REPORT OUTLINE FOR AREA PLANNING COMMITTEES**Report No.**

Date of Meeting	31 st March 2022
Application Numbers	PL/2021/08150 & PL/2021/08151
Site Address	POND CLOSE COTTAGE ANSTY SALISBURY SP3 5PU
Proposal	The demolition of an existing two storey residential annexe and modern conservatory at Pond Close Cottage (Grade II Listed), and the creation of a new two storey guest annexe, connected to the existing cottage by a discrete, single storey link.
Applicants	Mr and Mrs Tennant
Town/Parish Council	Donhead St Andrew
Electoral Division	Tisbury - Councillor Nick Errington
Grid Ref	51.029823, -2.100275
Types of application	Full Planning and Listed Building Consent
Case Officer	Jonathan Maidman

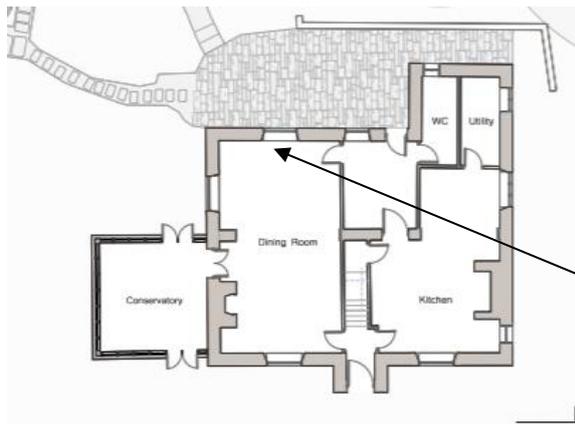
I do have one minor comment though and this relates to the link and the existing historic building. I note that the author of the heritage report says:

'The interior has not been assessed as part of these proposals' (4.4).

This is despite the fact that one window on the rear of the listed building is converted to a door. This will presumably entail the removal of said windows and removing the masonry below cill. The photo below, suggests this is an original window. Clarification should be sought and I would question whether this aspect of the proposals was necessary.

Window converted to door.
Photo/assessment of the
interest of this window is
required
